Safety Recall

Code: 97FR

Subject Engine Compartment Fuse Box Relays

Release Date August 13, 2021

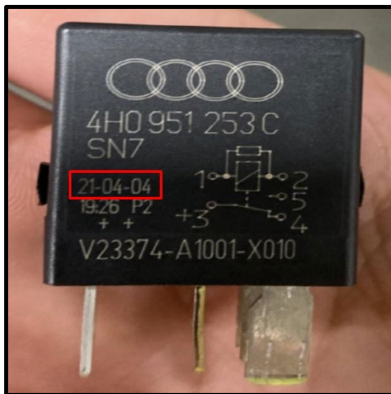
- Turn off the ignition and remove the key from the vehicle.
- Open the SB fuse panel cover under the hood.
- Check the “646” relays located in the SB fuse panel according to the map shown.

Depending on vehicle equipment, relay #4 may not be present.

- Remove each relay listed in the relay map (one at a time). When removing the relay, pull straight up. Do not wiggle the relay.
- Check the date code on the relay.
- If the date code is 21-04-04, replace the relay.
- If the date code is not 21-04-04, reinstall the relay.
- Once all relays are reinstalled or replaced, wait five minutes before turning on the ignition.
